UNITED STATES PATENT AND TRADEMARK OFFICE

Office Action Summary

10/743,710

DETAILED ACTION

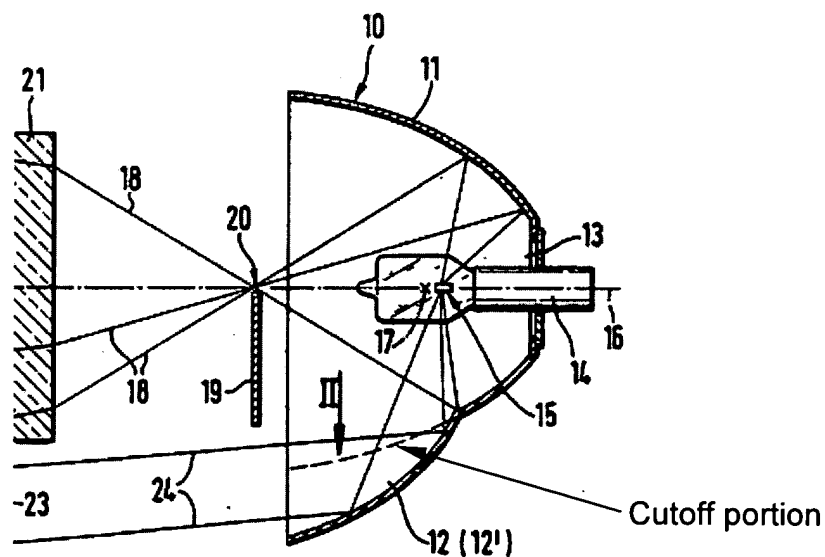
2. The drawings are objected to because cutout "1" in Fig. 1 does not agree with the descriptions: in the specification, page 5, lines 4-7, "a cutout 1 on one side of the plane passing through the geometric axis of the source S and **parallel to the optical axis Y-Y**"; and in claim 1, lines 7-10, "a cutout situated on one side of the plane passing through the geometric axis of the light source and **parallel to the optical axis** of the ellipsoidal reflector". Corrected drawing sheets in compliance with 37 CFR 1.121(d) are required in reply to the Office action to avoid abandonment of the application. Any amended replacement drawing sheet should include all of the figures appearing on the immediate prior version of the sheet, even if only one figure is being amended. The figure or figure number of an amended drawing should not be labeled as "amended." If a drawing figure is to be canceled, the appropriate figure must be removed from the replacement sheet, and where necessary, the remaining figures must be renumbered and appropriate

3. The disclosure is objected to because of the following informalities: on page 5, lines 4-7, "a cutout 1 on one side of the plane passing through the geometric axis of the source S and **parallel to the optical axis Y-Y**" does not properly describe the feature "1" in Fig. 1. Appropriate correction is required.

4. Claim 1 is objected to because of the following informalities: (a) Claim 1, lines 7-10, "a cutout situated on one side of the plane passing through the geometric axis of the light source and **parallel to the optical axis** of the ellipsoidal reflector" does not agree with the feature "1" in Fig. 1; (b) Claim 1, line 8, the phrase "the plane" lacks proper antecedent basis; (c) Claim 1, line 18, the phrase "the source" lacks proper antecedent basis. Appropriate correction is required.
